**Subject: *Discoverer Enterprise***  
**Reference: Acceptance of Well Control Equipment**

WEST Report #3925

Operator: BP  
Rig: *Discoverer Enterprise*  
Contractor: Transocean  
Location: GoM  
Water Depth: 5,000 feet  
Dates of Assessment: 28 April to 16 May 2010  
WEST Representatives: David Moore / James Regan  
WEST In-House Technical Review: Gene Nimmo  
WEST In-House Administrative Review: Lindsay Skinner

**Section 3: WEST Recommendation Summary and Disposition**  
**Discoverer Enterprise, Job #3925; 27 April to 16 May 2010**  
**Prepared for BP**

**Figure 1:** Damaged moonpool Coflexip type hoses

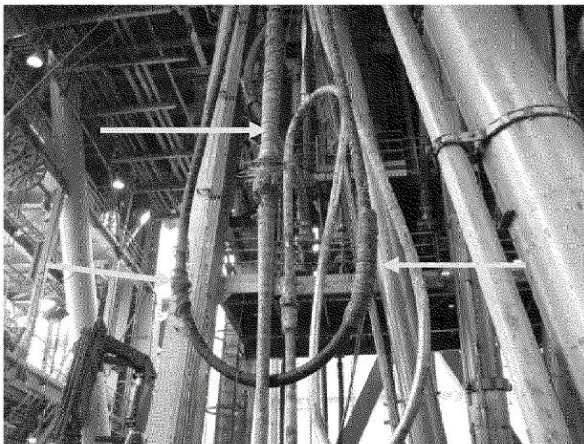
The Coflexip type hoses in the moonpool were visually inspected. All hoses in the moonpool were observed to have damage to the outer protective sheath, and will need to be replaced. It was also noted that the moonpool hoses didnot have safety slings installed. Safety slings should be installed from the rig hard piping to the Coflexip type hoses. Reference IADC Safety Alert00-24. See Figures 1 and 2.

**Figure 3:** Damaged riser buoyancy thrust collar.

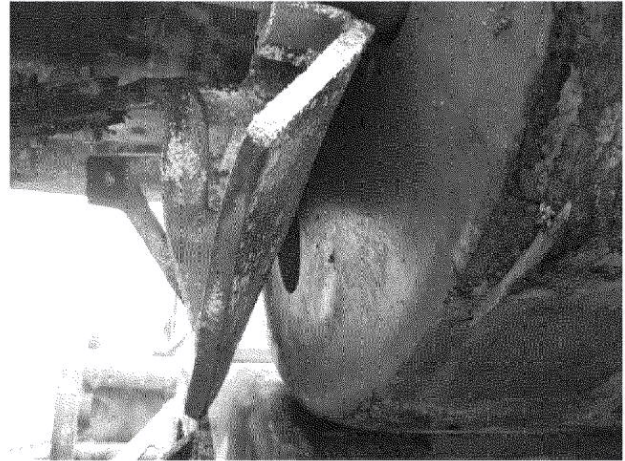
Several buoyancy modules were observed to be damaged; these damaged modules should be repaired. See Figure 3.

**Figure 4.3:** The yellow arrow shows the HC Collet Connector secondary unlatching cylinder, the two circles show the secondary piston seals, one of these two (or both) seals has failed causing operating fluid to migrate upward into the primary unlatching cylinder area, shown with the green arrow.

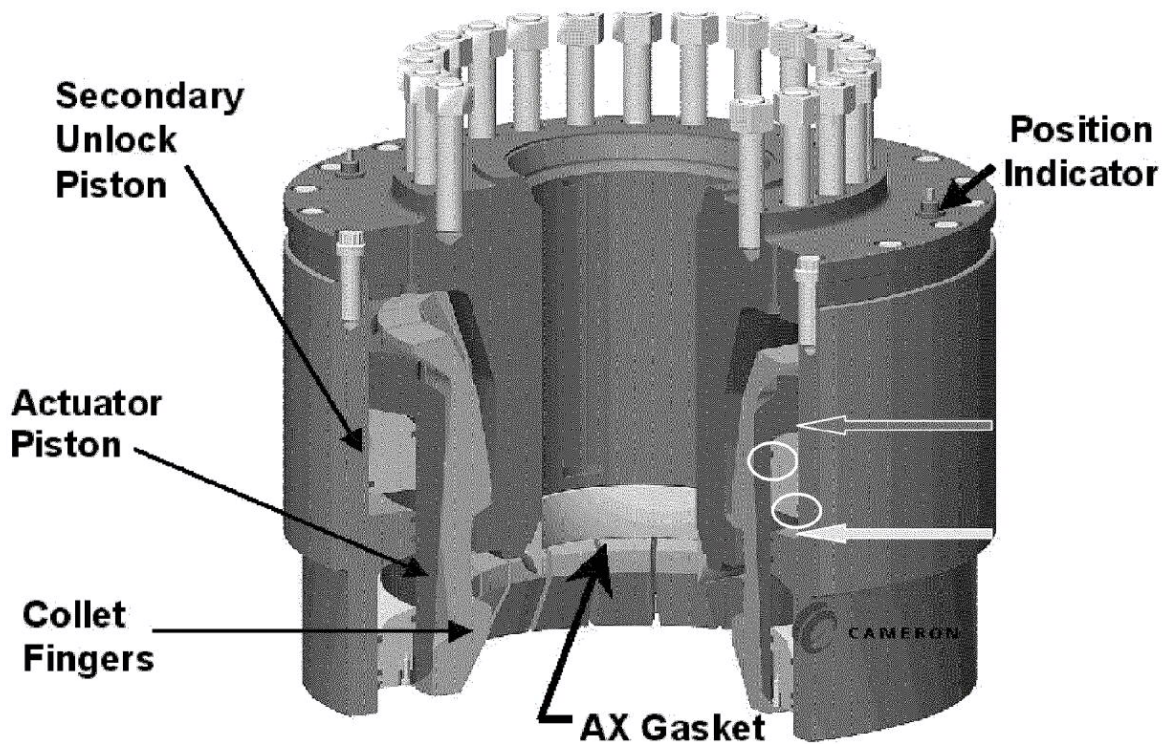
Figure 4.3 refers to the Cameron HC Collet Connector delivered to the rig to be fitted into the wellhead connector position.

Prior to fitting the connector had operator pressure tests carried out to determine the integrity of the hydraulic circuits. The primary lock circuit and primary unlock circuit's were both successfully tested to 3,000 psi /10minutes. The secondary unlock circuit could not be tested and was found to be communicating with the primary unlock circuit, fluid was visible leaking back through the primary port at the connector head. The leak was witnessed by WEST and Transocean, pressure testing was suspended awaiting a response from the OEM and Transocean management.

**Figure 5.1:** The aft middle pipe ram MPL locknut bearing that was replaced.

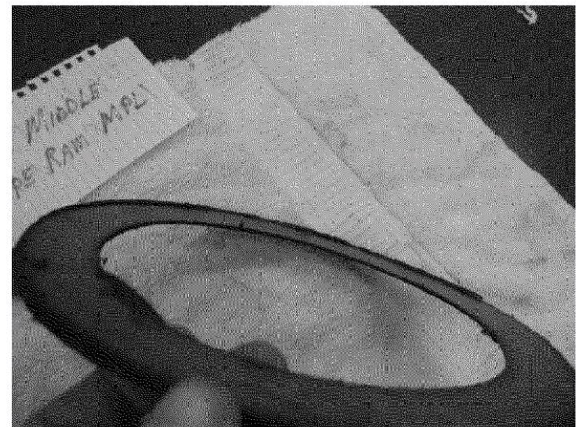
A signature test was performed on the aft middle pipe ram open and close ports. The pressure to open or close should be in the 100-200 psi range. The pressure to open the ram was 380 psi. If a pressure greater than 200 psi is required to open or close the ram, the locks should be disassembled for inspection. The MPL was removed from the housing and both locknut bearings replaced. The aft middle pipe ram MPL has yet to be retested. See Figure 1.

**Figure 17.1** Casing shear ram operator bolts to be replaced.

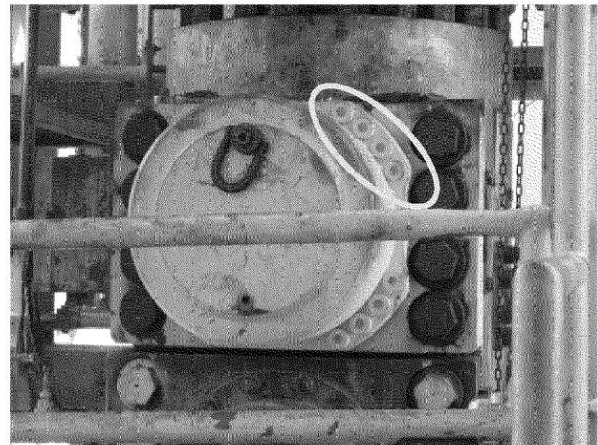
The workscope for tonight is to replace the 16 each forward casing shear ram operator bolts as per Hydril Advisory 09-001. See Figure 17.1. and Attachment A. Once the new bolts are installed the bolts will be torqued to 1,700 ft/lbs using Moly 503 lubricant. The bolts are 1-1/2" x 5-1/2", Hex head, Xylan coated and Inconel 718 precipitation hardened.
